TRANSFORMER POWER UNIT POWER
 UNIT: 300
 274700; TURNED OVER TO UE
 7/6 AM 8/26/52

D-75-569 16

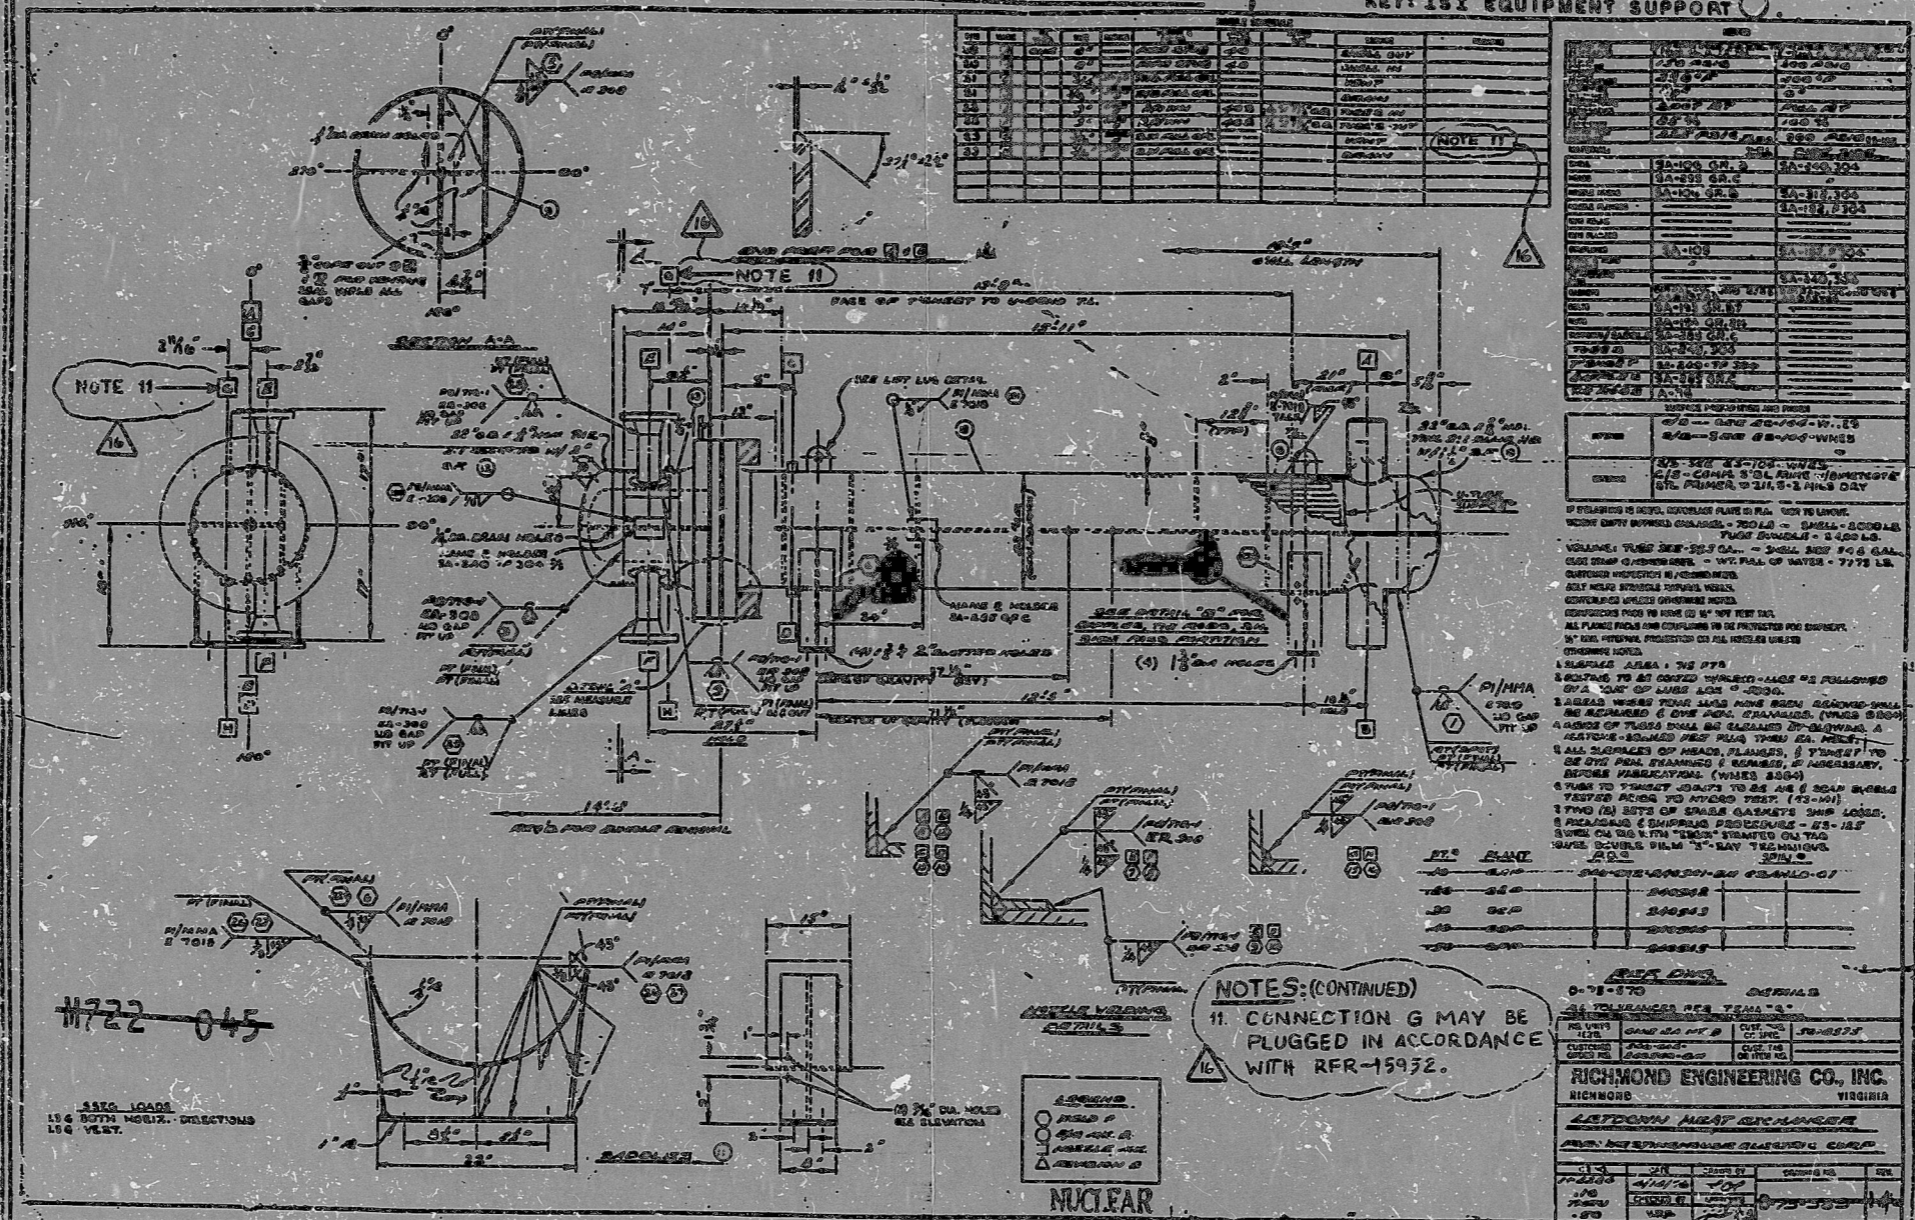
RECHTEL NOTES
 1. ADDED UNIQUE EQUIPMENT SUPPORT NOS. FOR
 353 PER ULB-496 (5-10-55). NO FIELD WORK
 REQUIRED.
 KEY: ISX EQUIPMENT SUPPORT

NOTES (CONTINUED)
 11. CONNECTION G MAY BE
 PLUGGED IN ACCORDANCE
 WITH RFR-15952.

INCORP
 ULB-496 &
 EFR-15510A

INCORP.
 RFR-15952
